SUBJECT: Forwards response to RAI re review of request for amend dtd 970929 for TS related to main steam line isolation signal setpoints.

Subject: Response to Request for Additional Information (RAI)
Rochester Gas & Electric Corporation
R.E. Ginna Nuclear Power Plant
Docket No. 50-244

Reference: Letter from G.S. Vissing, NRC, to R.C. Mecredy, RG&E, Subject: *Request for Additional Information - Review of Request for Amendment Dated September 29, 1997 - Change to the Technical Specification Related to the Main Steam Line Isolation Signal Setpoints (TAC No. M99702)*, dated April 3, 1998.

Response to RAI of April 3, 1998

SG Pressure (psia)

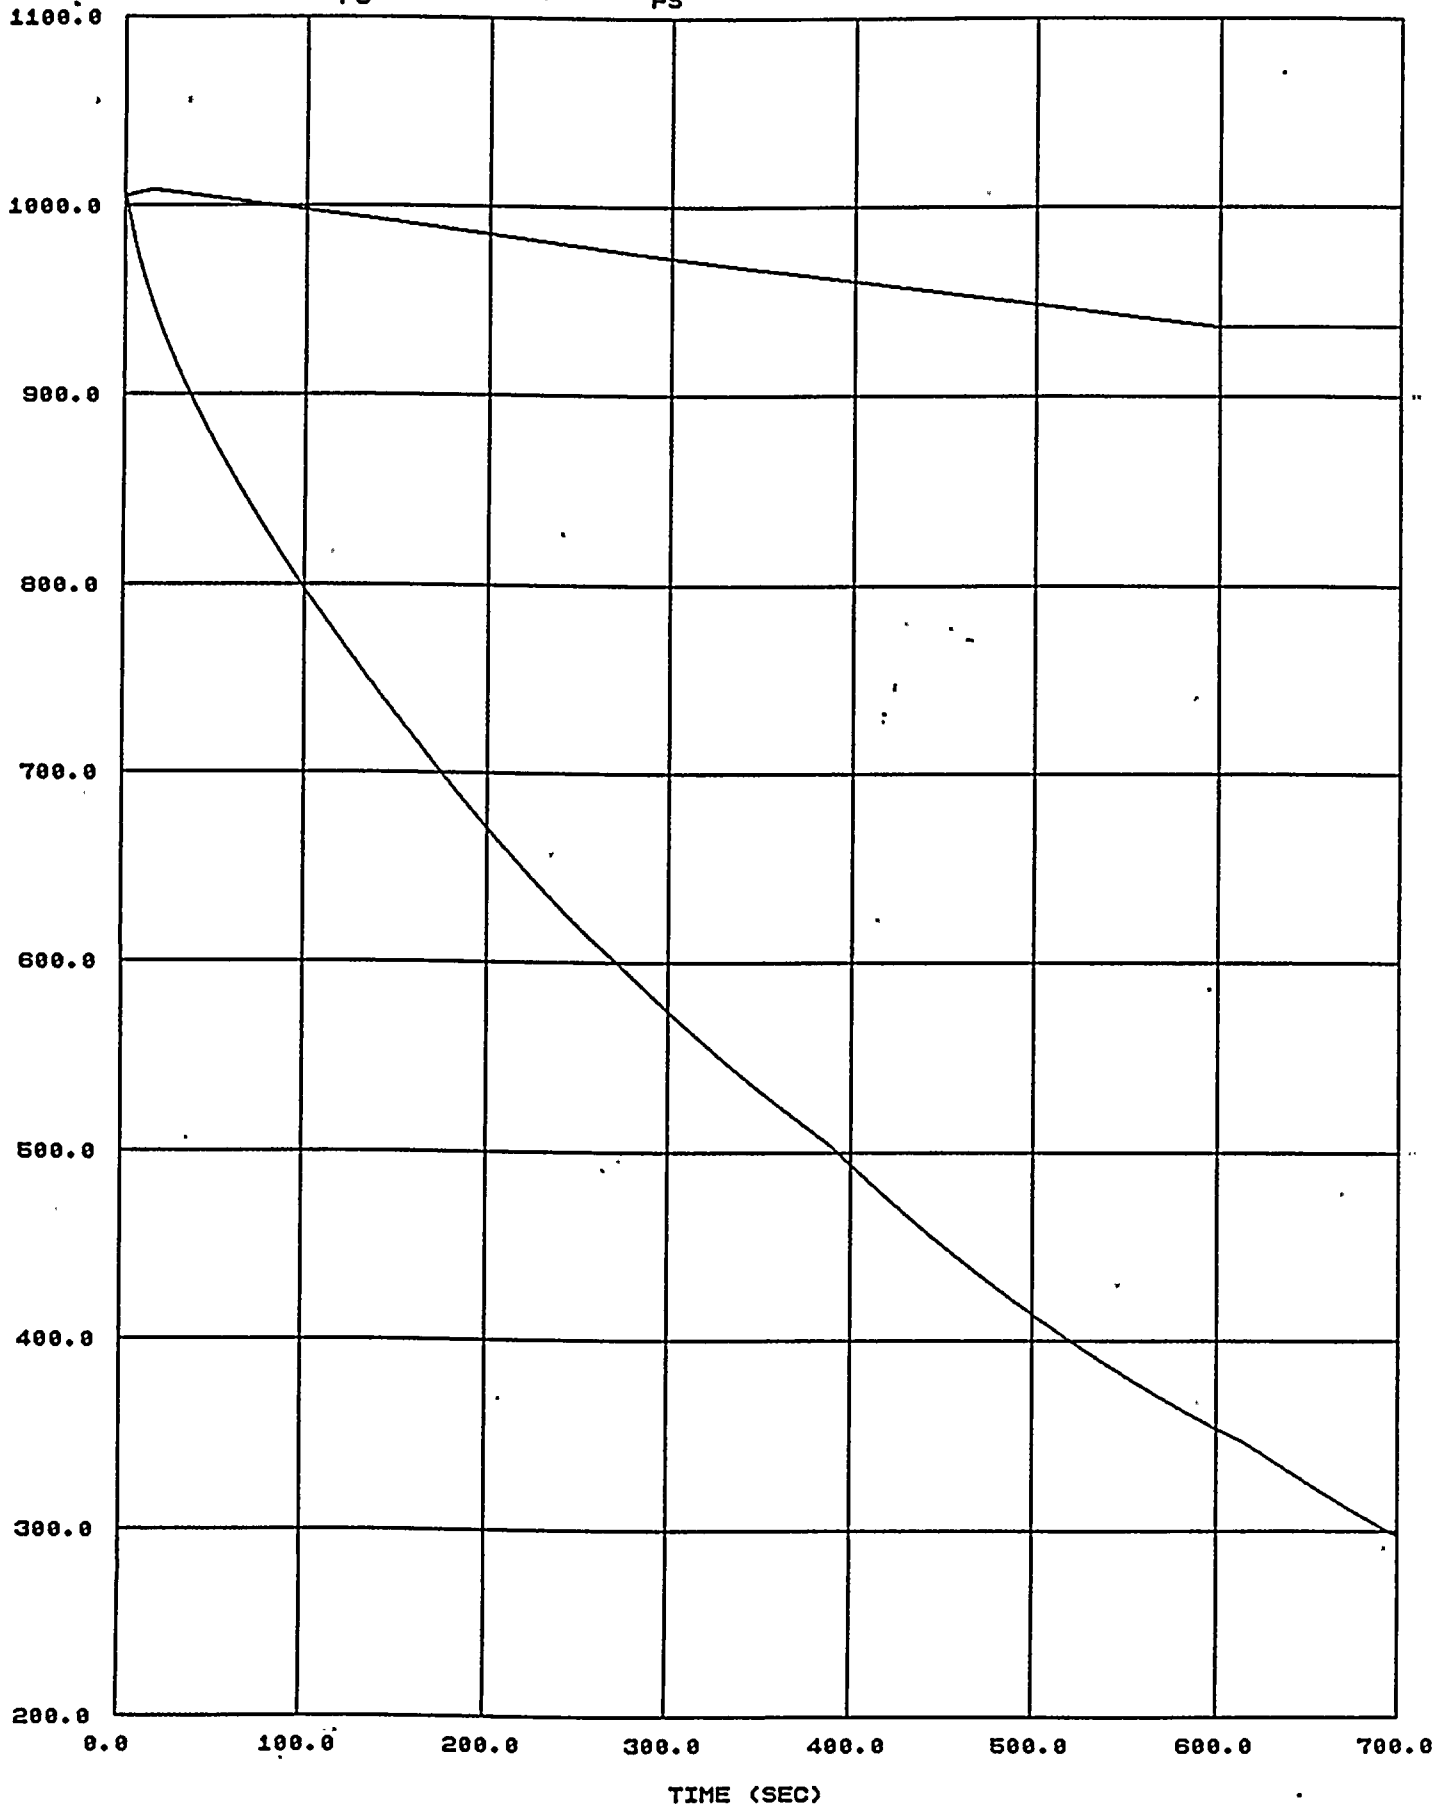
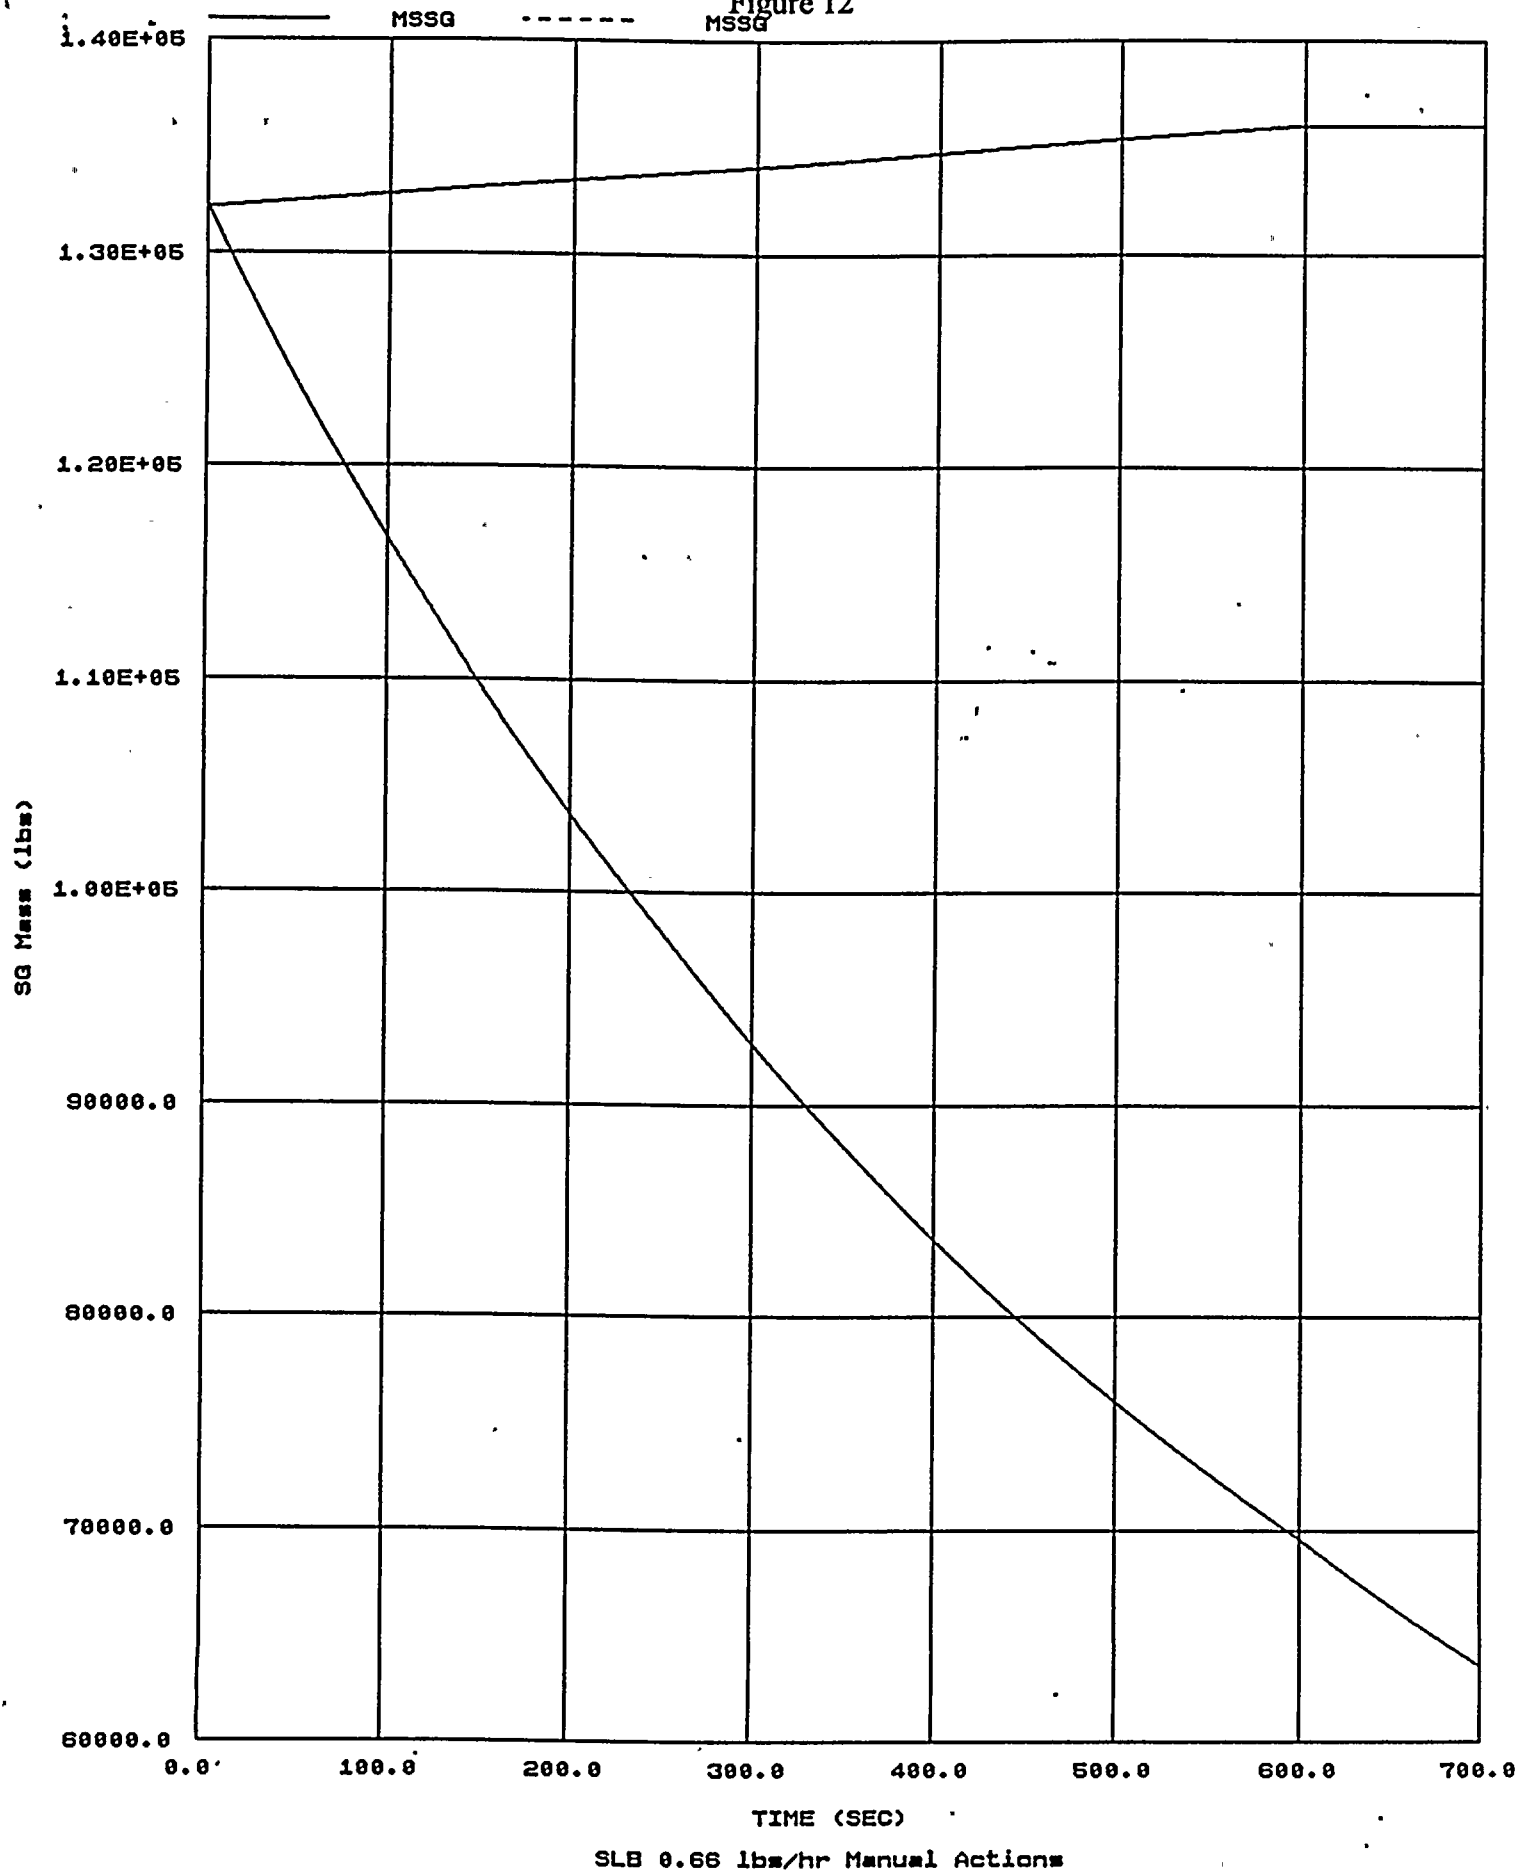
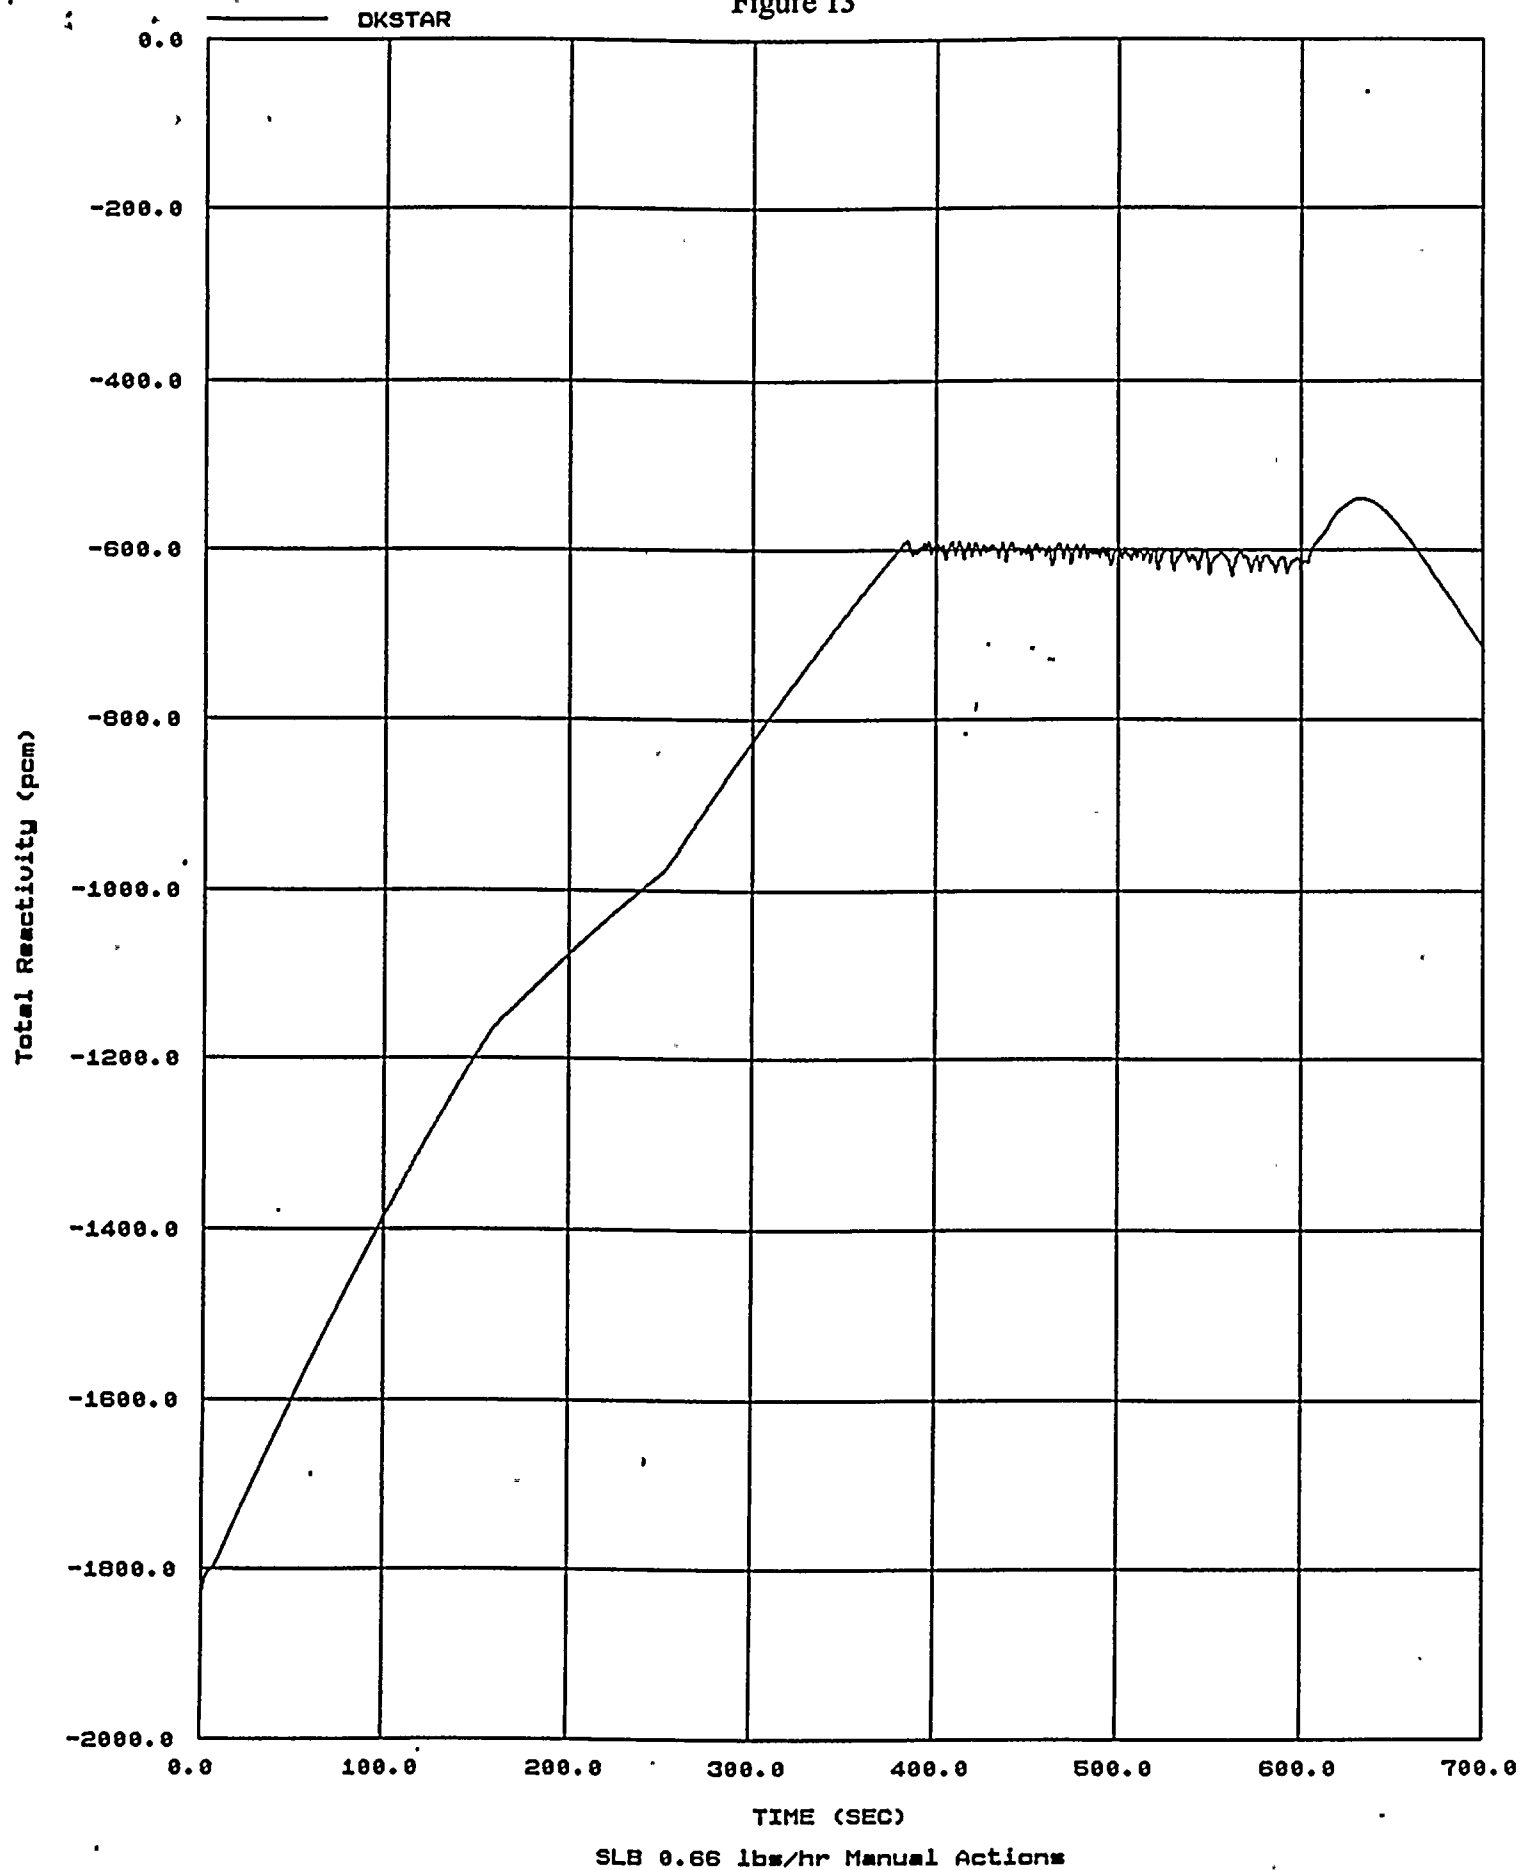
2. *Please provide the results of your reanalysis.*

Attached Figures 1 through 7 represent parameters from Case 5-O. Figures 8 through 14 represent parameters from the 0.66E6 lbm/hr steam line break in one steam generator described in the February 6, 1998 RG&E letter (hereafter referred to as Case SLB). A comparison of the parameters shows:

- a. Resulting nuclear power is less for Case SLB;
- b. Resulting RCS temperature reduction is less for Case SLB;
- c. Resulting pressurizer pressure reduction is less for Case SLB;
- d. Resulting steam generator pressure reduction is less for Case SLB;
- e. Steam generator mass trends illustrate the difference between a feedwater malfunction and a steam break;
- f. Total reactivity insertion is less for Case SLB but occurs over a longer time frame; and
- g. The rate of reactivity insertion is less for Case SLB.

In summary, the parameters indicate that the Case SLB is less severe than Case 5-O and that the limiting criteria with respect to the reactivity insertion rate is less than that for Case 5-O. Therefore, UFSAR Case 5-O remains bounding.
